**Response to Further Information Request (Ref: SD21A/0161)
Lucan Shopping Centre, Newcastle Road, Co. Dublin**

ERF Lucan Investment DAC

We write on behalf of our client, ERF Lucan Investment DAC, in response to the Council's request for further information in respect of planning application ref: SD21A/0161.

Figure 3: Block 1 Somerton & Proposed Link

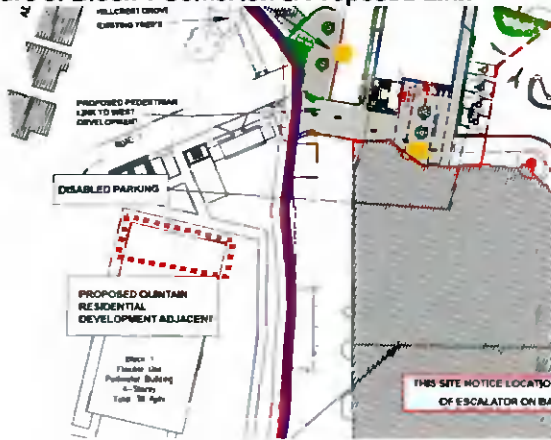
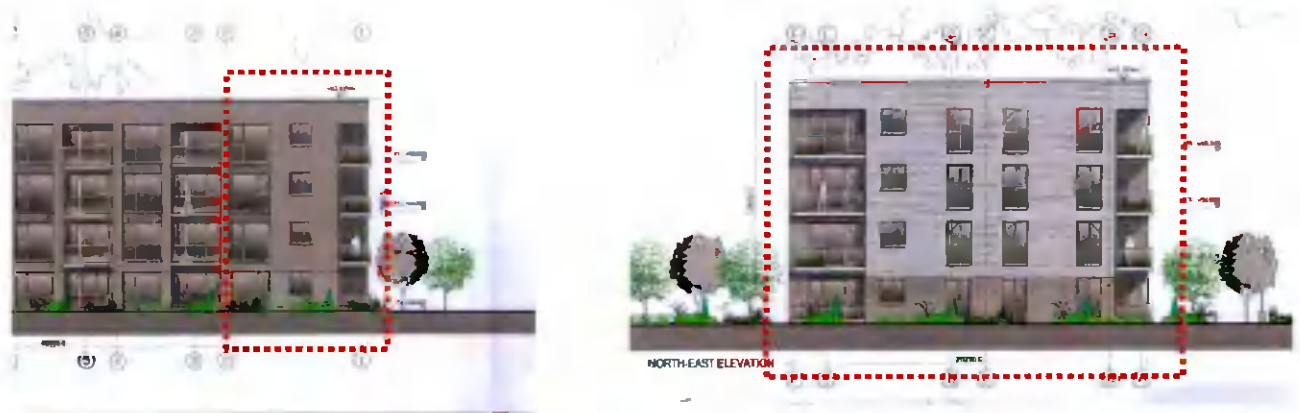
The pedestrian/cycle connection is not significantly overlooked or provided with perceived passive surveillance.

We also note that the proposed link will benefit from passive surveillance from Block 1 of the Somerton development. This will comprise four storeys of balconies and windows from kitchen / living spaces and bedrooms.

The link will also benefit from the formal security arrangements of the Shopping Centre during trading hours. This includes on-site management staff, security, and extensive CCTV coverage. The combination of passive and active surveillance during trading hours will ensure that any anti-social behaviour is discouraged.

Figure 4: Alternative Pedestrian / Cycle Routes Considered

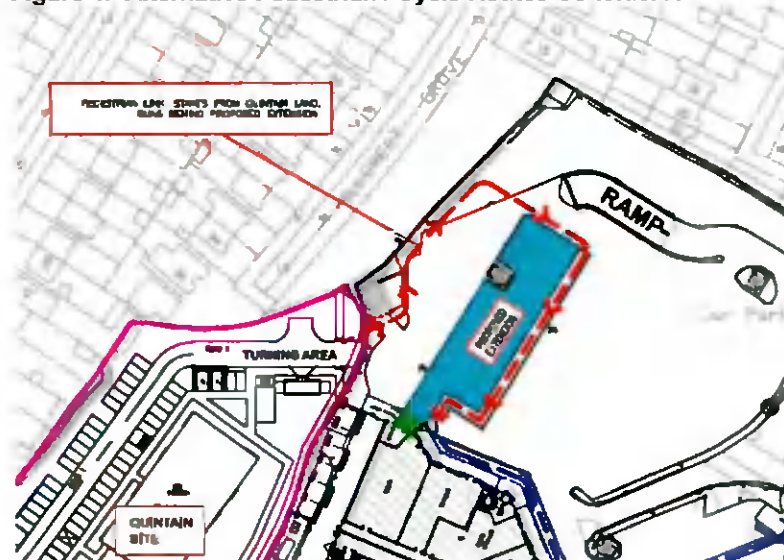
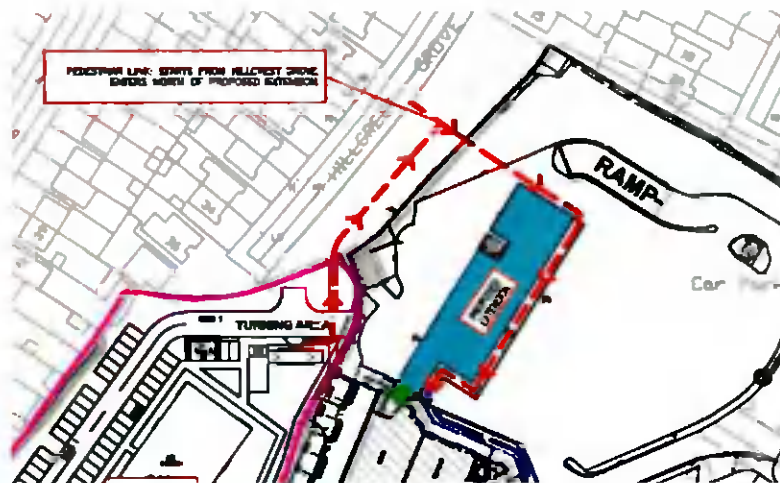
It has not been demonstrated that the proposed route/connection would not give rise to anti-social behaviour. The applicant is therefore requested to provide, as additional information, an alternative layout and design proposal, showing how pedestrians will be facilitated in accessing the site safely through a modified and widened pedestrian link, which provides perceived passive surveillance/overlooking of the access. It should be clearly demonstrated that the pedestrian and cyclist takes priority at this location on the site. In particular, the applicant should demonstrate that the proposed development would not limit the access of the public at any time of the day or night, the planning authority would suggest a complete separate service route from the pedestrian route, the planning authority also request fully detailed drawings clearly demonstrating safe and high quality linkages to the adjacent housing estates Hillcrest and the Somerton development and how the proposal will respond to these residential estates. A significant redesign should be submitted.

Alternative arrangements for the proposed pedestrian / cycle link were considered during the design feasibility and pre-planning meetings with the Council. These were:

1. Segregated pedestrian / cycle route to the rear of the service yard running to the north of the proposed extension; and
2. Entering the site from Hillcrest Grove to the north of the proposed extension.

Each proposal presented significant technical or ownership challenges. They increased the travel distance for pedestrians and cyclists accessing or egressing from the Shopping Centre. Furthermore, they were likely to increase the potential for anti-social behaviour due to less passive surveillance offered.

Figure 5: CGIs of Proposed Development

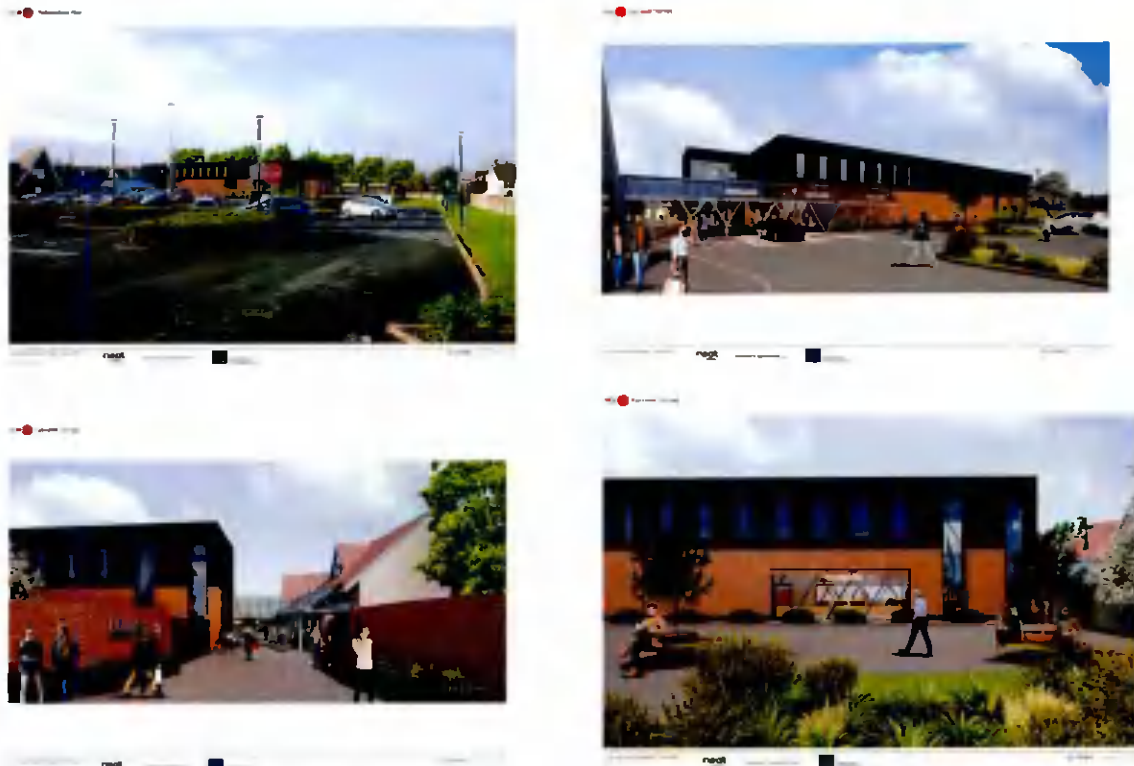
c) Photomontages / illustrations of the impact of the proposed development should be submitted.

This submission includes Computer Generated Images (CGIs) of the proposed development. We trust that this demonstrates the quality materials and design of the building, customer plaza, and pedestrian / cycle link.

Figure 7: Revised Elevations

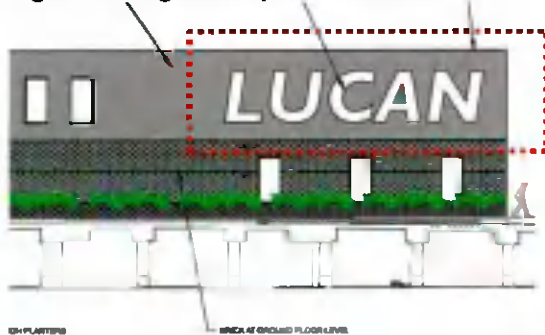
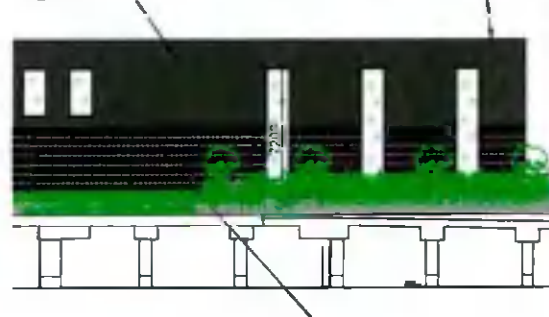
The applicant is requested to demonstrate that the proposed signage is compliant with County Development Plan policy Variation No. 5 – Outdoor Advertising (South Dublin County Council Development Plan 2016 – 2022). The applicant proposes to have 4 signs on the eastern facing

elevation, one external and three internally via the glass windows. The applicant is requested to provide a revised design layout of the proposed signage to be consistent with variation No. 5 of CDP.

The applicant has amended the proposed front elevation to remove the large 'LUCAN' signage. As detailed in Figure 7 below, the signage has been replaced by three double height windows to further animate the elevation.
